ADDENDUM No. 1

Solicitation Title: 32' Traffic Circle Project

Solicitation No.: IFB No. 43-07-15 Opening Date: October 14, 2015 at 3:30 pm

PROPOSED TRAFFIC CIRCLE INTERSECTION AT NE 12 AVENUE AND NE 131 STREET

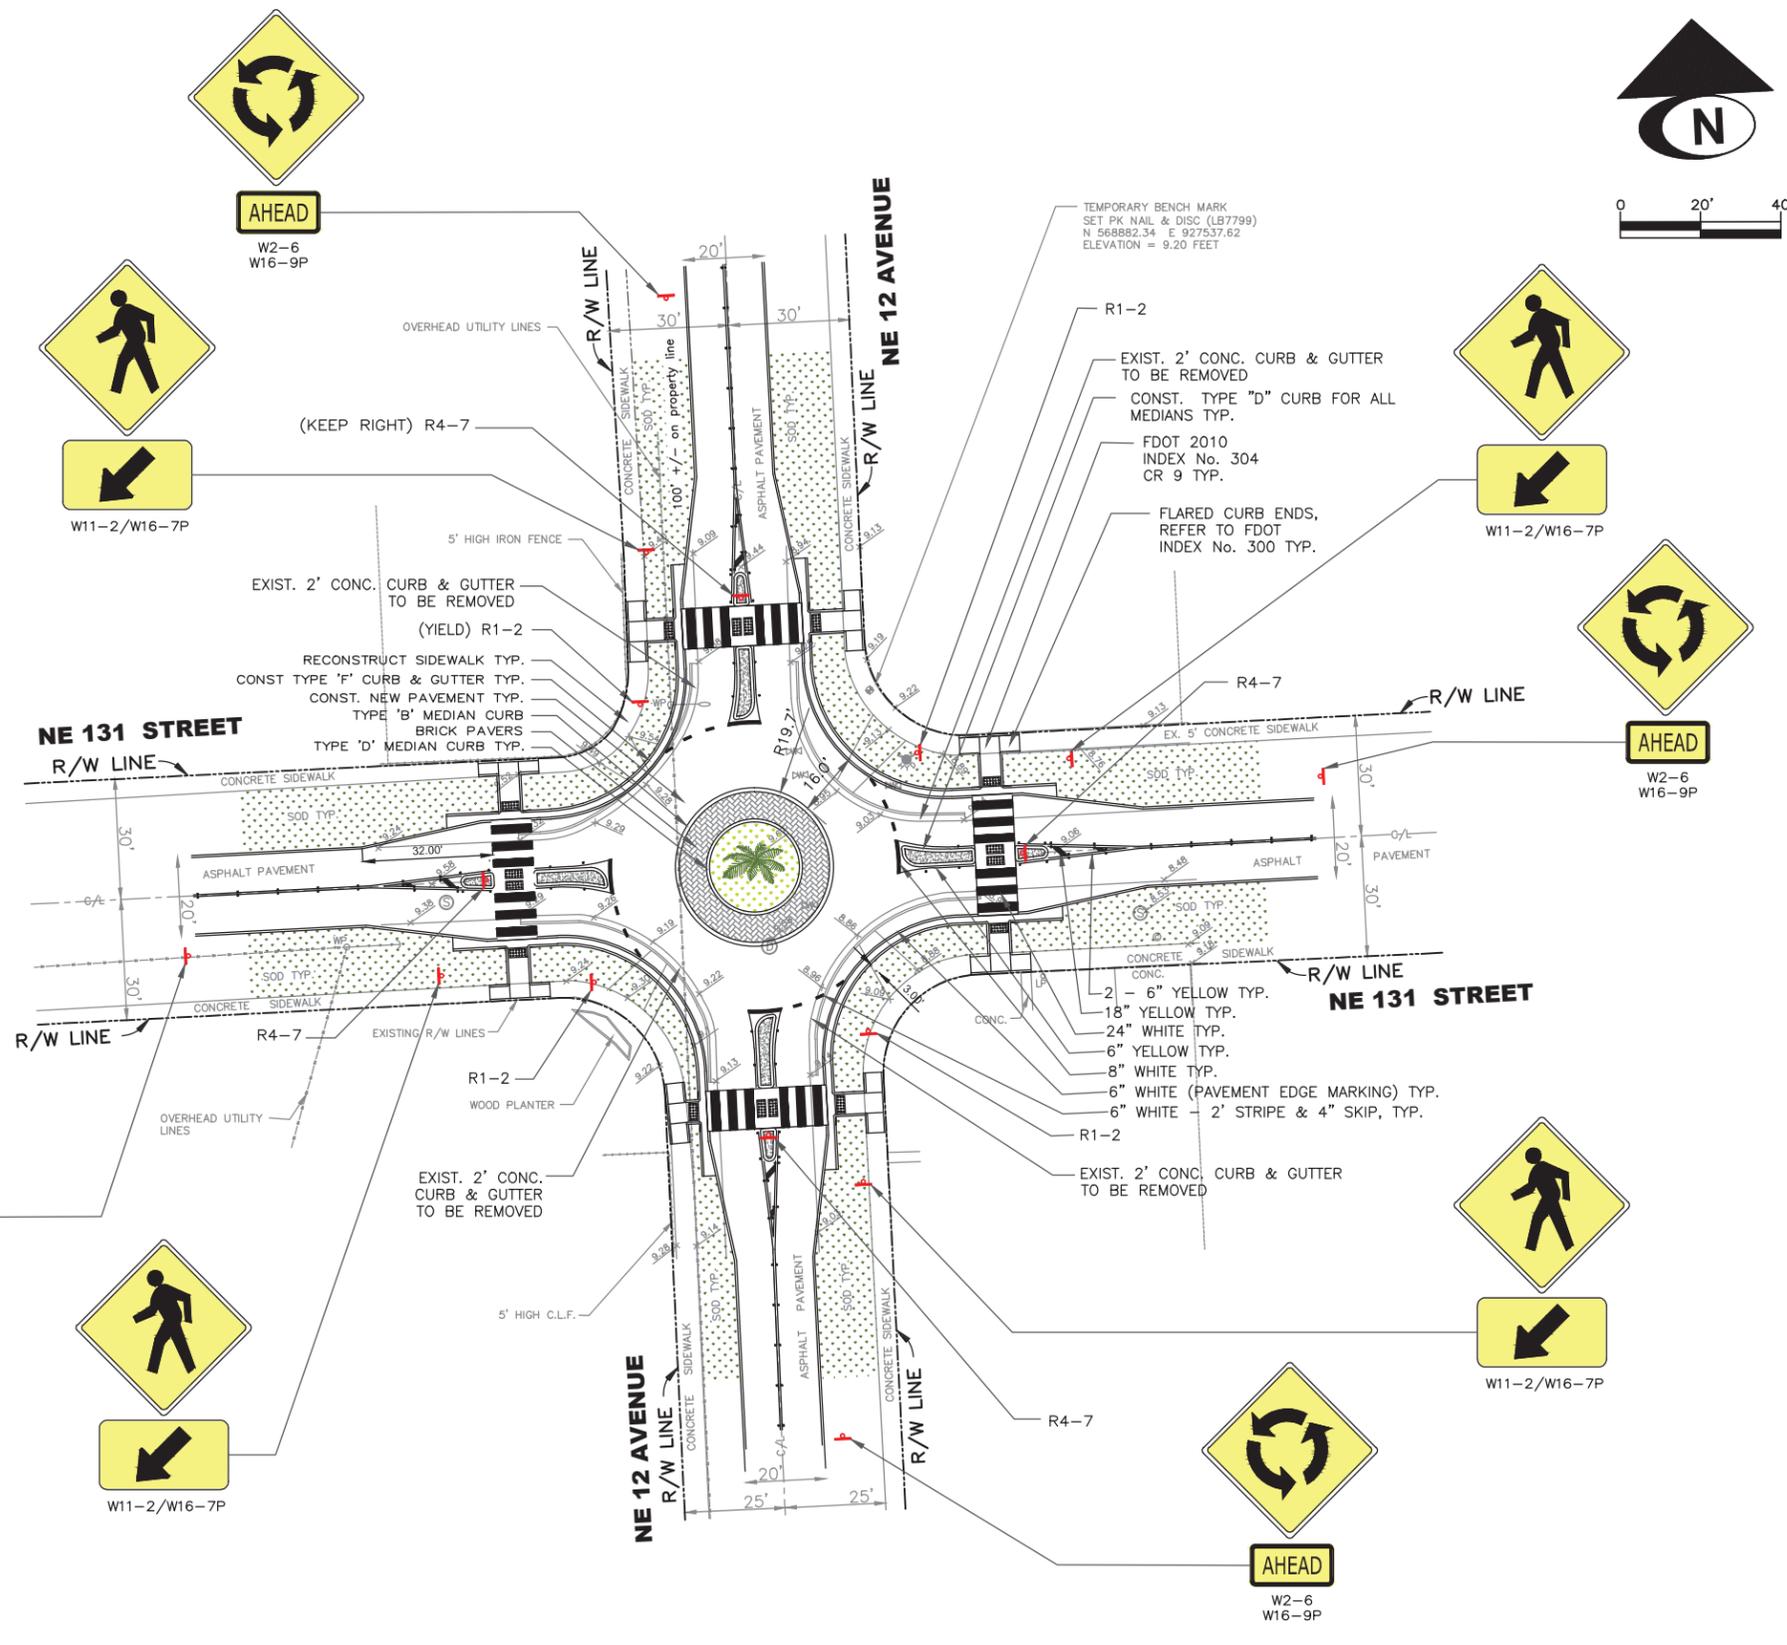
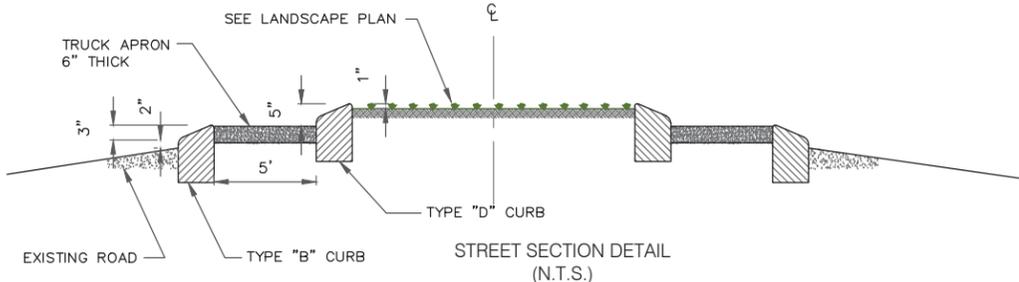
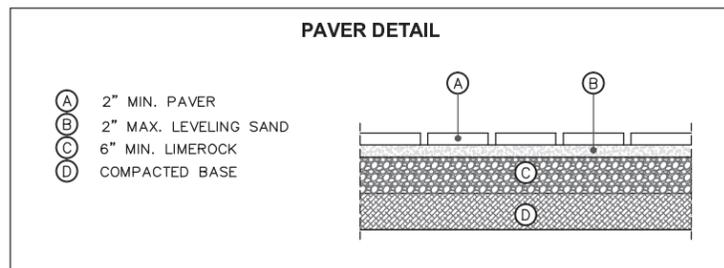
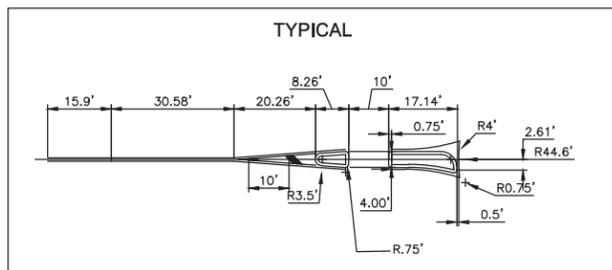
Q.1 "On Drawing No. 2 of 8 the cross section shows Type B curb inside and outside. The plan shows Type B and D. Please clarify"

Q.2 "Could you please provide us with a new cross section showing the items below:
A) Color, thickness and pattern of the pavers
B) What type of material we will install under the pavers and thickness"

Q.4 “What type of curb will be at the islands?”

A.1 See revised attached drawing 2 of 8 for clarification. (Attachments B and C)

A.2 A) Color and pattern of pavers will be reviewed and approved by the City of North Miami prior to installation. See the new PAVER DETAIL on drawing 2 of 8 (Attachments B and C) for the thickness of the pavers.

B) See new PAVER DETAIL on drawing 2 of 8 for the type and thickness of materials to be installed under the pavers. (Attachments B and C)

A.4 As specified in the updated drawing 2 of 8 (Attachments B and C), the curb at the islands shall be type “D” as shown by the added call-out, “CONST. TYPE ‘D’ CURB FOR ALL MEDIANS TYP.”
